**MICHIGAN DEPARTMENT OF ENVIRONMENTAL QUALITY**

**INTEROFFICE COMMUNICATION**

SUBJECT: Review of the May 4, 2009, Comprehensive Remediation Plan (CRP)  
submitted by PLS.

## Figure 1

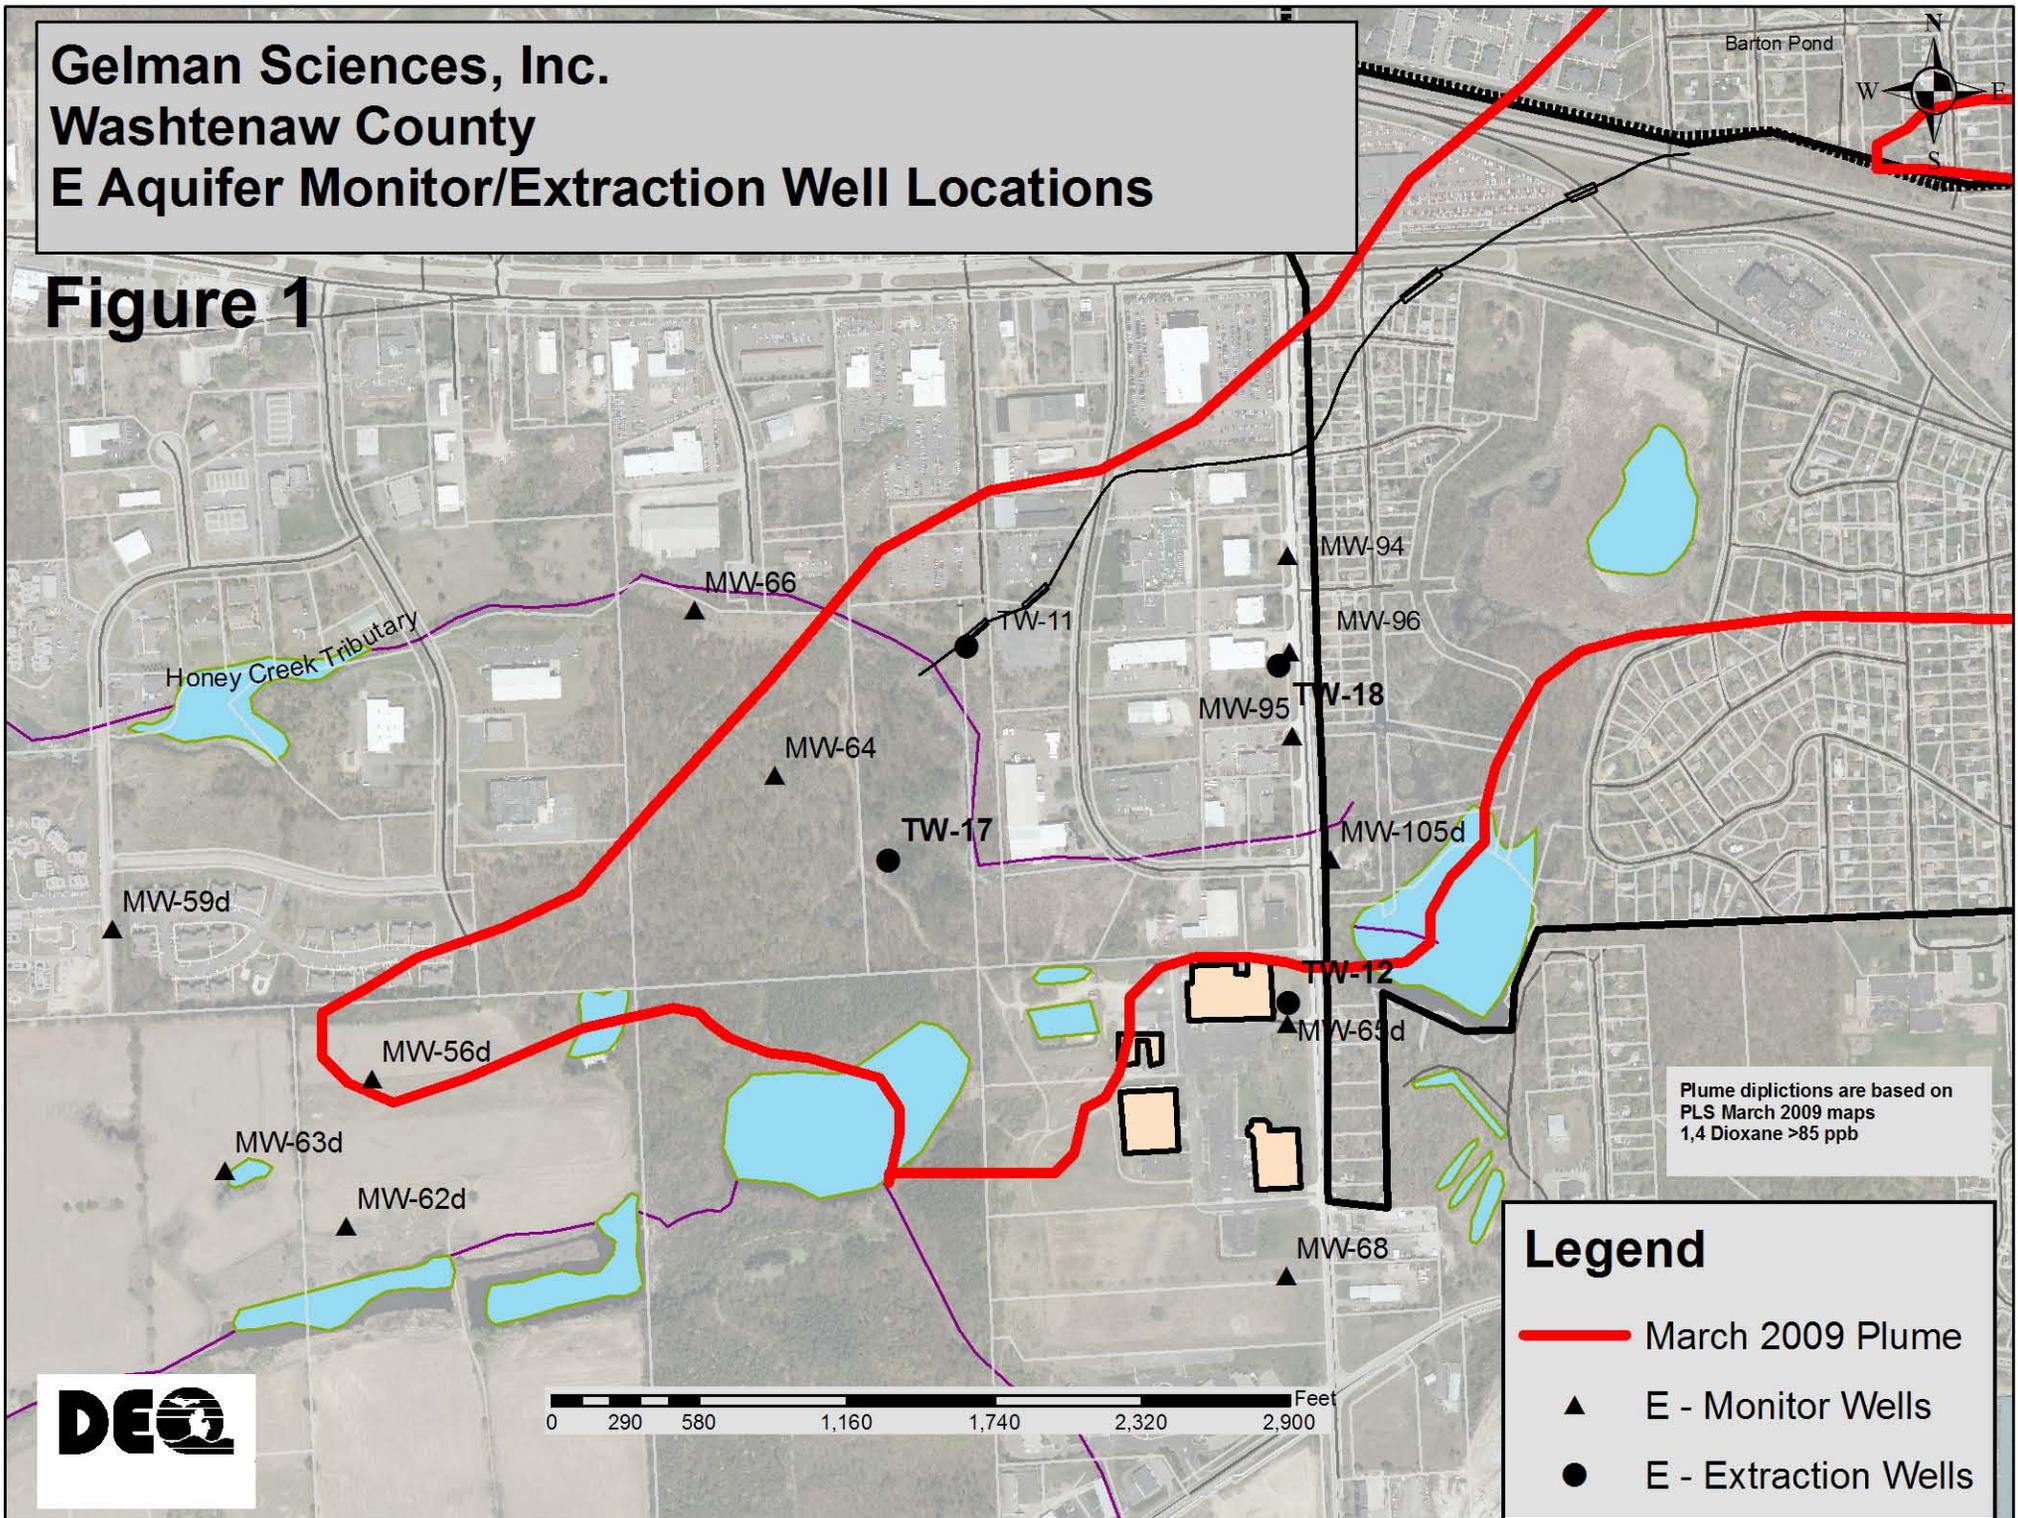
As seen in Figure 1. there are only two deep (Unit E) monitoring wells (MW64 and MW-66) between monitoring wells MW-56s/d and MW-118, a distance of approximately 4800 feet. As noted above, PLS depicts a Unit D<sub>2</sub> 85 ug/l isoconcentration contour between the MW-56s/d and MW-118/Wagner Road locations. PLS appears to utilize data from a combination of Unit C<sub>3</sub> and D<sub>2</sub> monitoring wells as a basis for this 85 ug/l boundary. Additional characterization of the deeper intervals and permanent monitoring wells are needed at the MW-39s/d, MW-34s/d, MW-36, MW-33, MW-11s/i/d, MW-13, Nancy Drive (PLS08-07), and MW-14d locations to define the extent of contamination, and to establish the basis for compliance monitoring.

A minimum of four monitoring wells should be installed between MW-68 and MW-56d. These wells should be screened at appropriate intervals to demonstrate that 1,4-Dioxane above 85 ug/l, will not migrate south or southwest beyond the compliance boundary. See Figure 2 for our suggested locations.

Pursuant to the source control requirements of Section 20118(8) of Part 201, and the source identification and evaluation element of Rule R299.5528(3)(g) a minimum of six well clusters, at 500 foot well spacing, should be installed on a north – south axis, through the core area, Figure 2. These wells should be vertically profiled to bedrock. The transect of monitoring wells should be installed from the area near technical boring PLS 98-01, south to the area immediately west of MW-68. These wells are necessary because there are no Unit E monitoring wells west of Wagner Road that establish where the source of Unit E contamination originates from, and/or provides an estimate of how much contaminant mass remains in the Unit E source area.

To be consistent with Rule 528(3)(I), and Section 20118, additional wells are needed at the following locations (see Figure 2):

A nested well should be installed at the PLS former technical boring location GSI96-01. A well is needed in this area to define the vertical distribution of 1,4-Dioxane contamination, and to evaluate plume geometry and flow paths into the Evergreen subdivision.

An additional well, west of the GSI96-01 location, (Columbus Dr./I-94 area?) will be needed to define the western extent of contamination. The western well should also have the capability (>85 ug/l) of serving as a PZ compliance monitoring well.

Additional monitoring wells be required midway between the Columbus Dr./I-94 well, and monitoring well MW-121. The distance between I-94 and MW-121 appears to be approximately 1400 feet. These well(s) are needed to define the western extent of contamination and to establish that the source of contamination in DuPont Circle is not from and area west of, or outside of the proposed expanded PZ.
